Access Compliance Report

Public Rights-of-Way

(Curb Ramps)

Intersection ID: N/A	Main Street: WILTHSHIRE_MANOR_DR	Cross Street: LADBROKE_CT	Location: SE
ADA ID: A4D4D11ADF06	Ramp Type: Directional1	Initial Pass/Fail: Fail	Overall Compliance: No
Codes/Mitigation Info/Possible Solution			Severity Score: 10
			Field Measurements/Component Compliance

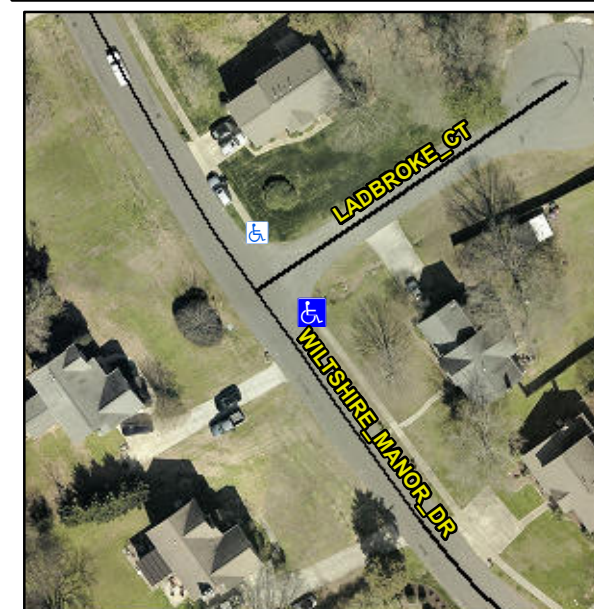
R304.5.1, R304.5.3

Remove & Replace Entire Ramp.
